Addendum No. 1

2009 Washoe Flume Rehabilitation

Bid # 0910-112
September 17, 2009

FIGURE
01

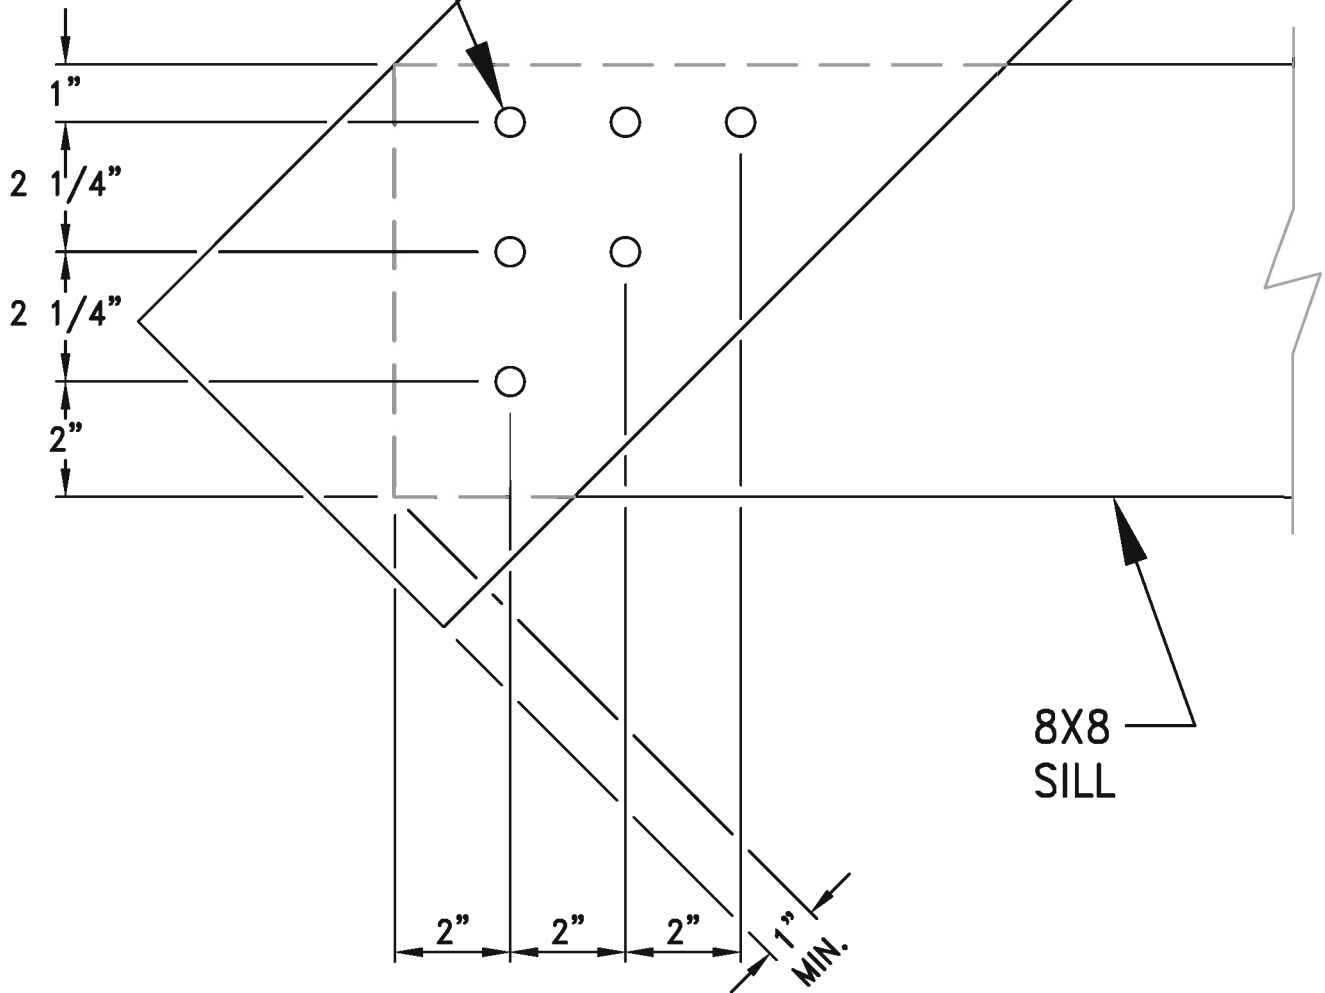
1. The nail pattern for the knee braces has been revised per the attached Figure 01. A similar pattern of six nails is to be used for the top connection to the post. Add the attached Figure to the bid drawings.
2. The Bid Schedule and Bid Item Description have been modified per the attached sheets. Bid Item 4 has been added as shown. Replace the originally provided documents with the attached documents.

30d (0.192"X4 $\frac{1}{4}$ ")
SINKERS. SIX
TOTAL SPACED AS
SHOWN.
